MORGAN SHOAL COMMUNITY UPDATE

PROJECT 22703: CHICAGO SHORELINE PROTECTION PROJECT 45TH STREET TO 51ST STREET (MORGAN SHOAL)

REVETMENT RECONSTRUCTION

March 21, 2024

Keweenaw Peninsula, Lake Superior

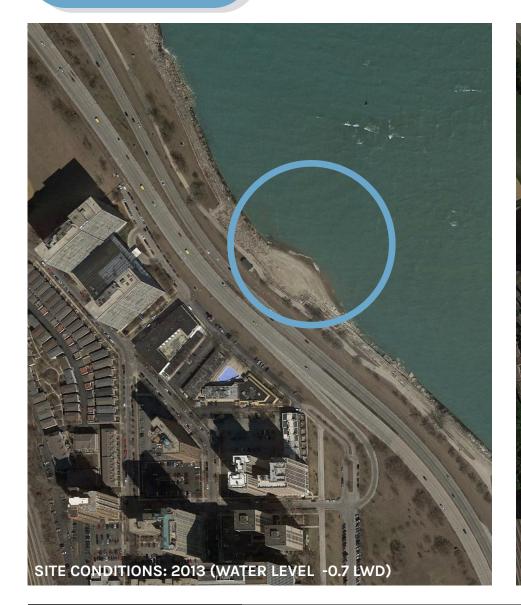
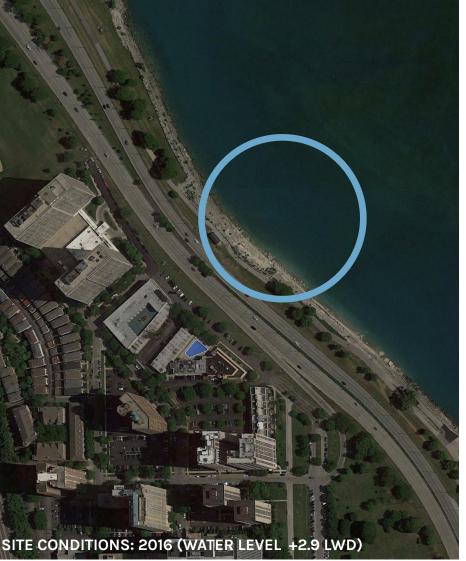
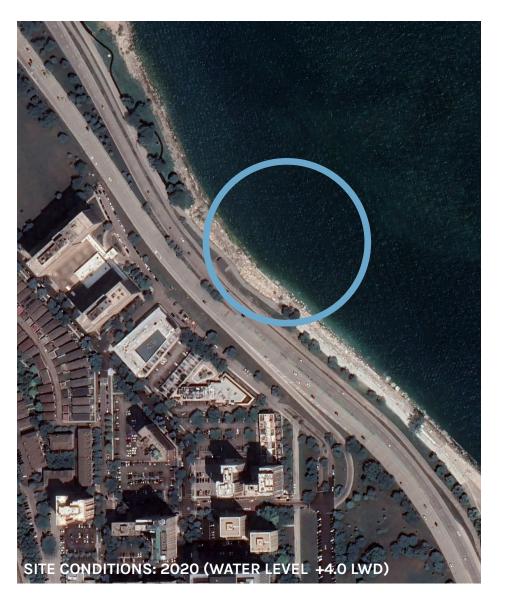
"Other examples of dynamic revetments? More details of what dynamic revetments are constructed of?"

"Why must pebble beach be destroyed?"

"What will become of the natural pebbles and rocks that are currently on the beach. Please collect and reuse them"

- A dynamic revetment differs from a typical revetment primarily:
 - has a shallower slope
 - uses much smaller material
 - undergoes some re-shaping resulting from waves
- The dynamic revetment replicates a natural cobble beach
- All available existing pebbles will be salvaged and added to the new 1- to 5- inch cobbles. The new structure will be much bigger than the existing pebble area

Bender Park, Oak Creek WI

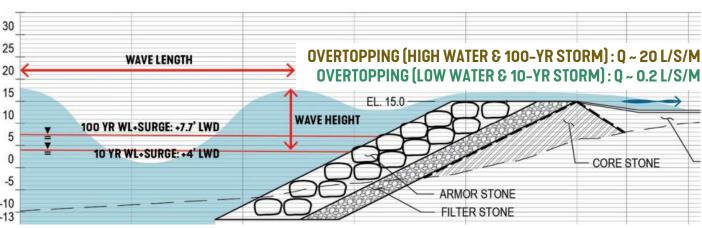
"I really appreciate the rugged nature of the shore and pebble beach....why does the plan look so smooth and manufactured?"

"Why is there NO natural shoreline in the plan?"

- The graphics utilized in the earlier meeting presentation materials showed an overall concept of the project plan and do not focus on the inherent irregularity of construction with large armor stone and existing salvaged limestone
- The sloped armor stone revetments will have many crevices and interstitial spaces for aquatic organisms to utilize for refuge and foraging

51st St existing concrete installed in 1970 is deteriorated and limits safe pedestrian access to water

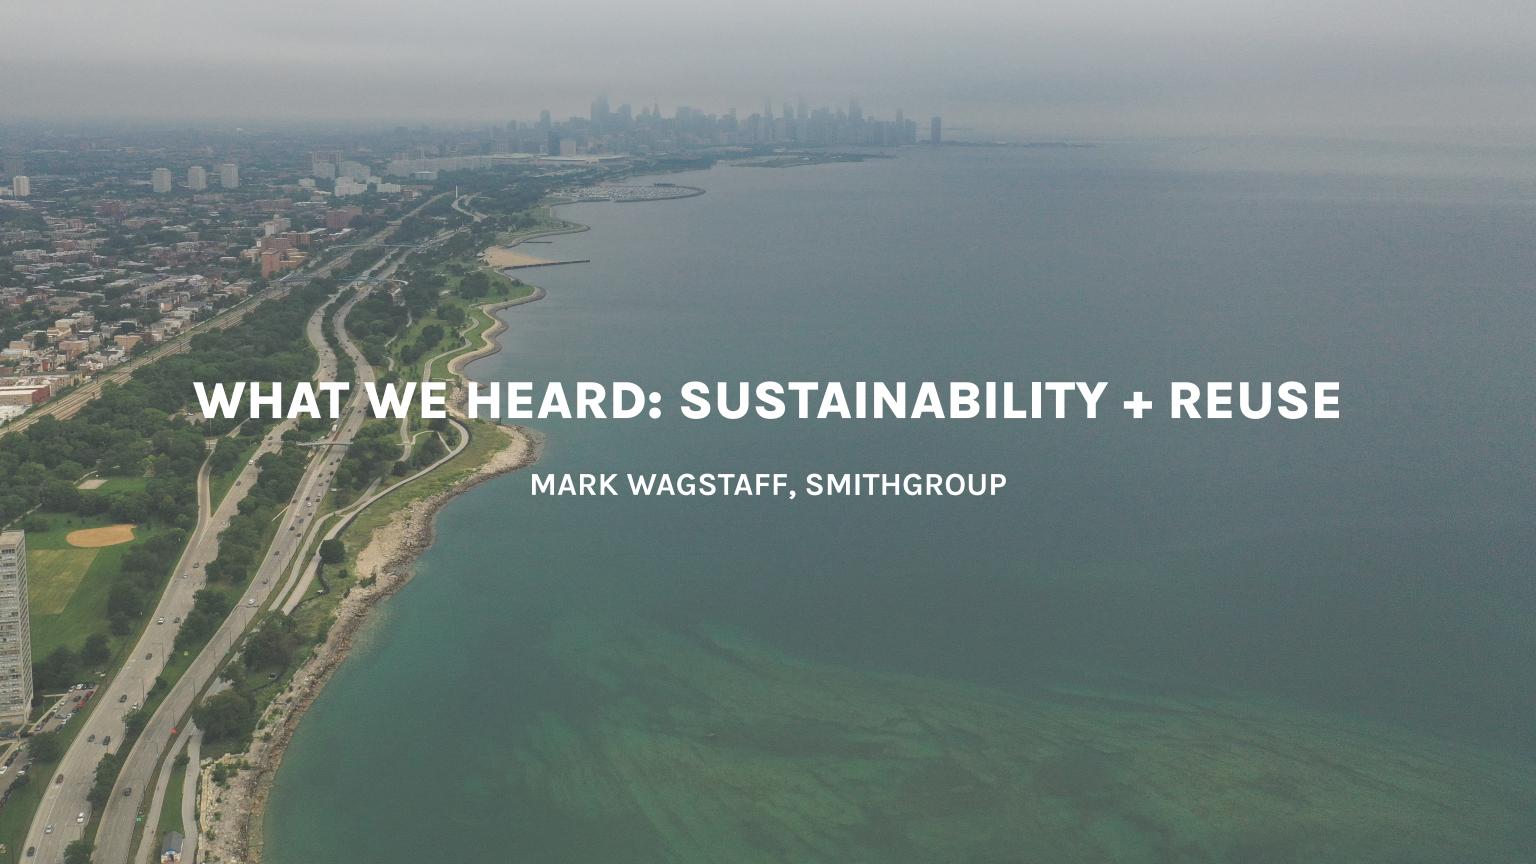
Why not use limestone as it is sustainable and worked for many decades?

The plans appear to show an abundance of sloped stone that will be a barricade to lake access. Why cant we have stepped stone instead?

"Please NO CONCRETE by the water!"

- Improves existing access to water's edge and is only 15% of the project length
- Illinois Accessibility Code requires a compliant connection to the existing 51st to 54th St Revetment
- Prevent shoreline erosion and loss of park space
- Create equitable access to the lakefront

- The existing timber crib and limestone structures in this specific project area - which have been substantially repaired and added to several times over their lifespan, have now failed.
- The majority of the proposed shoreline protection for this stretch of lakefront is armor stone revetment (which is constructed from natural stone materials, including limestone) which is a durable solution.
